**Re: Proposed Starbucks
944 South Main Street
Cheshire, Connecticut
SLR #141.17378.00001.0040**

Please find attached a revised site development plan set that was approved by the Cheshire Planning and Zoning Commission. These plans show a bioretention basin in the 50-foot upland review area on the east side of the property adjacent to the Mill River that was not shown on the design plans referenced in the Cheshire Inland Wetlands and Watercourses Commission (CIWWC) permit letter issued on January 25, 2021. This bioretention basin was requested by the Regional Water Authority in a review letter from Mr. Ron Walters to the Cheshire Planning and Zoning Commission dated December 10, 2020. The basin was requested to enhance stormwater quality treatment from the adjacent building and paved areas prior to discharge to the Mill River. The basin also provides flood storage volume to mitigate proposed filling in the Federal Emergency Management Agency (FEMA) 100-year floodplain. The design of the bioretention basin and floodplain storage computations not completed at the time of the CIWWC decision.

PILE

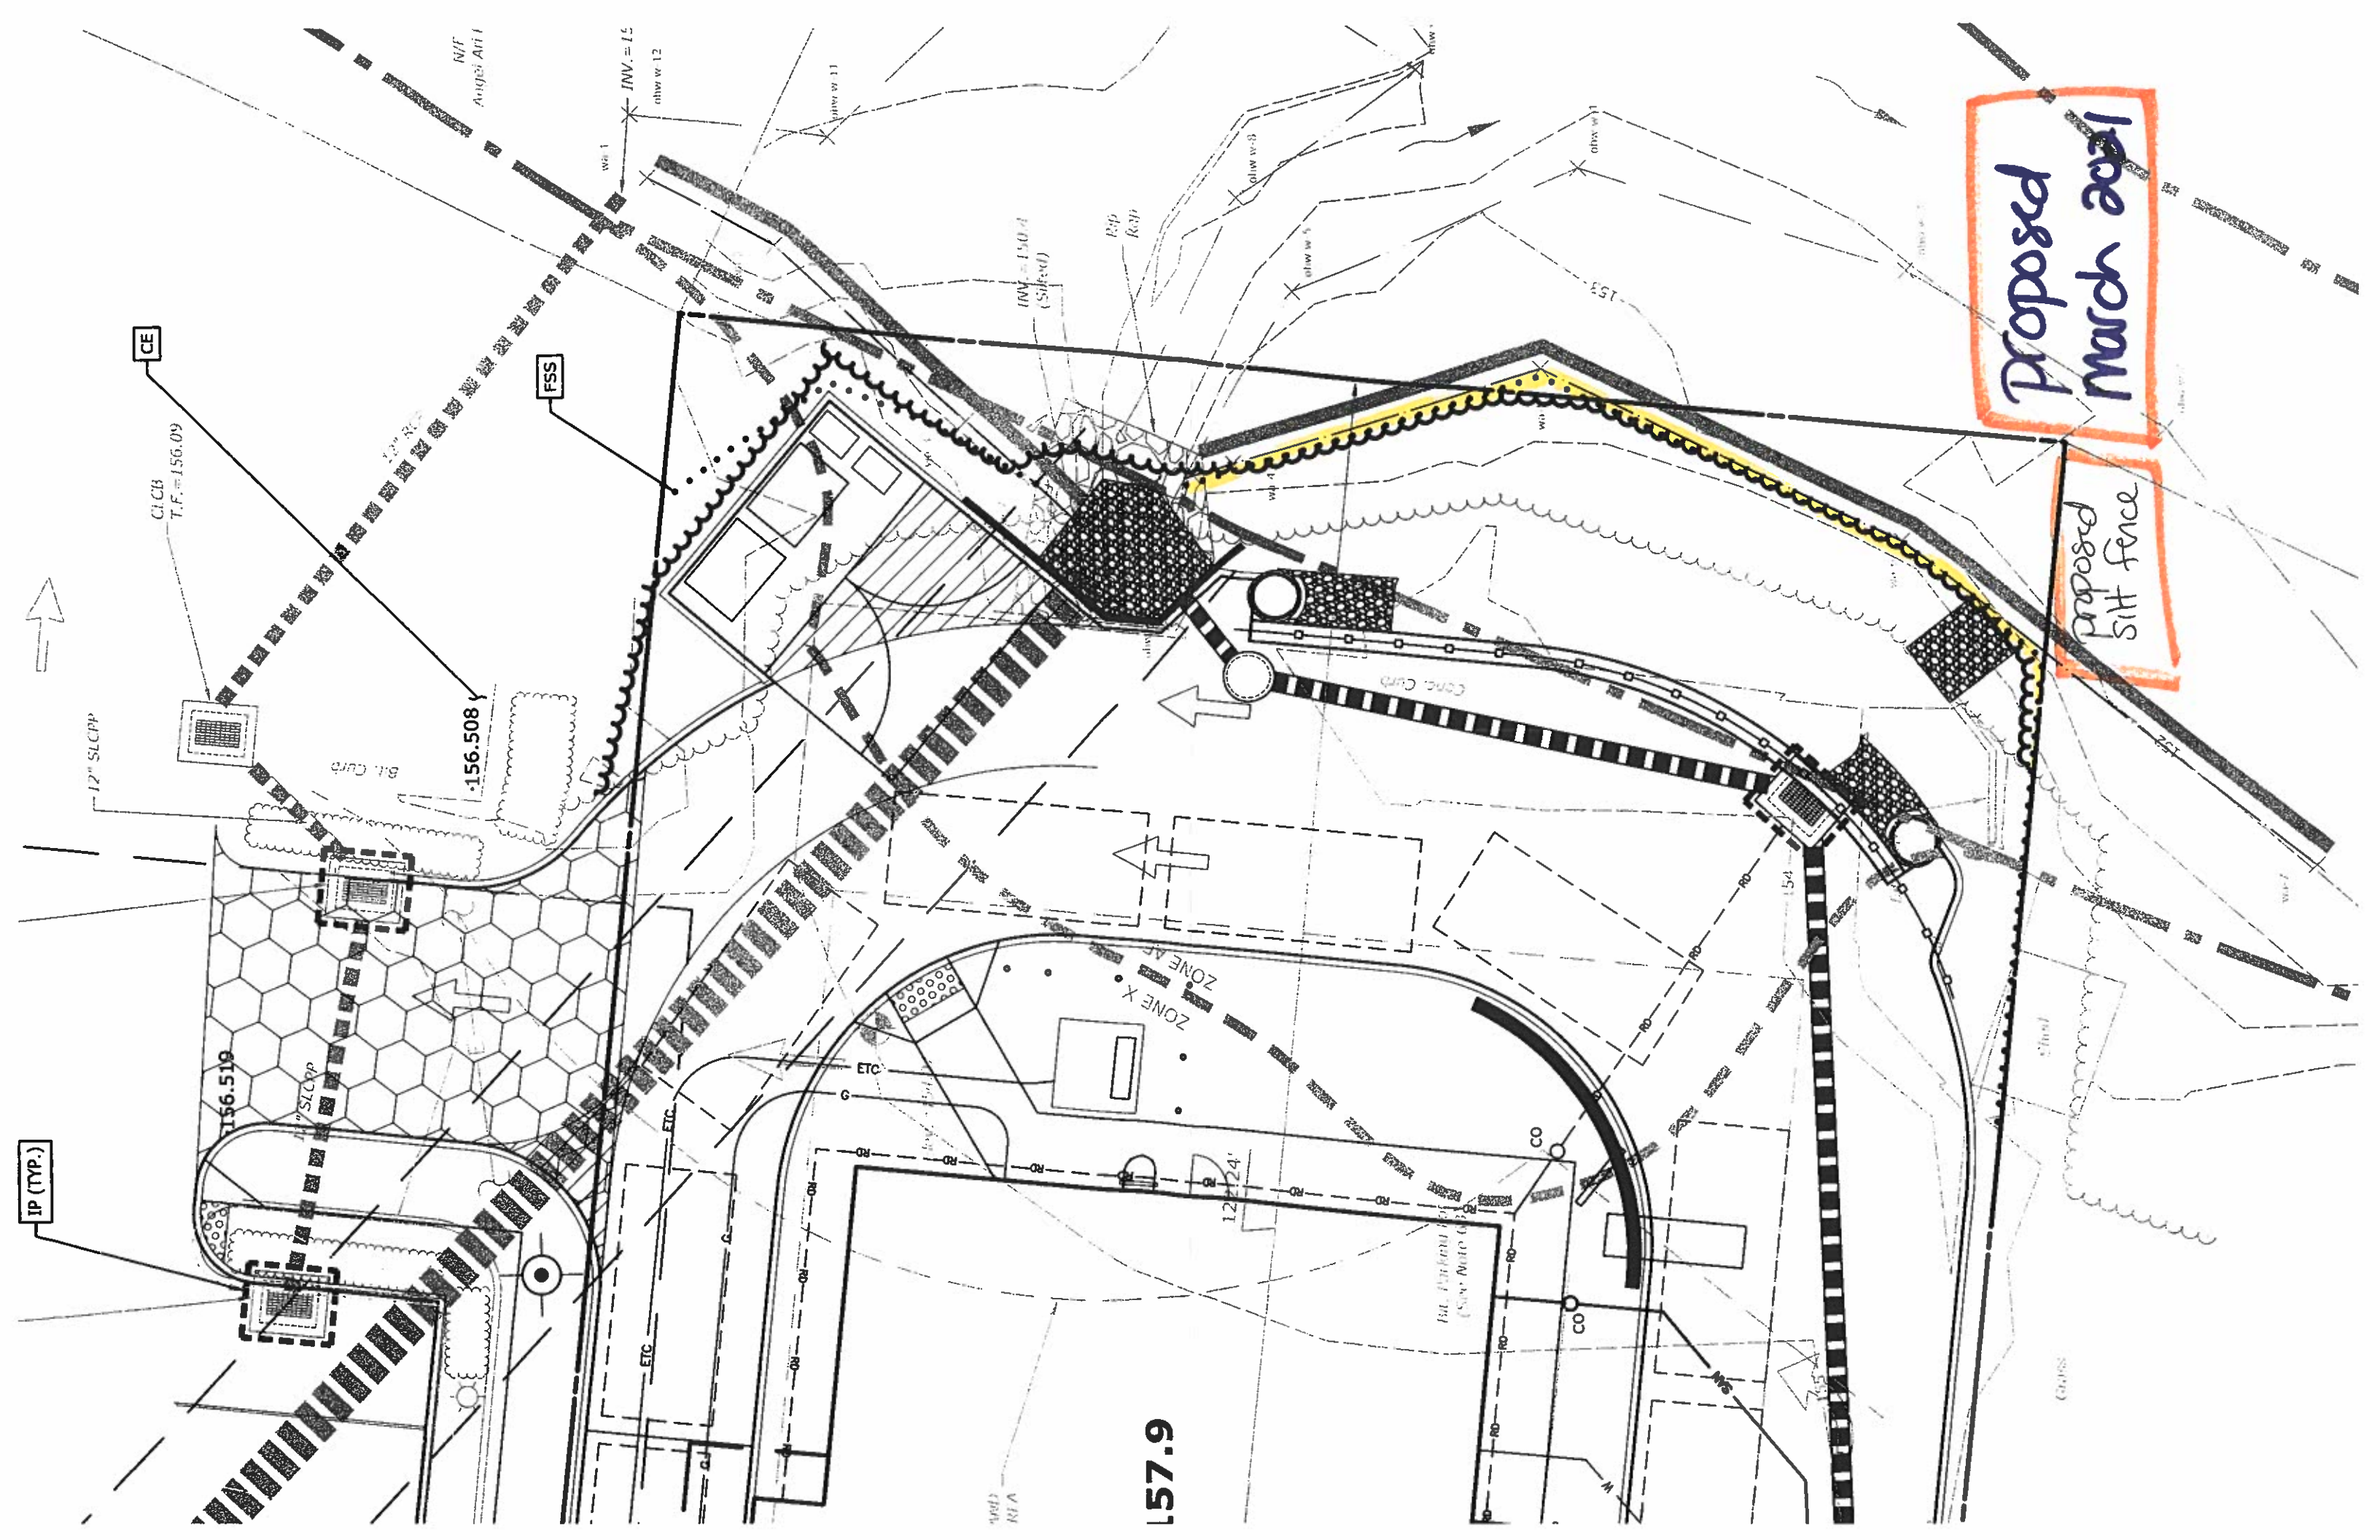
While the permitted upland review area disturbance does not change, the grading and proposed plantings have changed to accommodate the bioretention basin. We are submitting these plans for review so that CIWWC is aware of the change and that both permit files are complete. Therefore, we are requesting that the Commission review these plans as a permit determination to confirm that the plan as proposed does not represent a new impact that would require a modification of the permit. However, should a permit be needed, an updated application is also attached.

BIORETENTION BASIN
SEE DETAIL
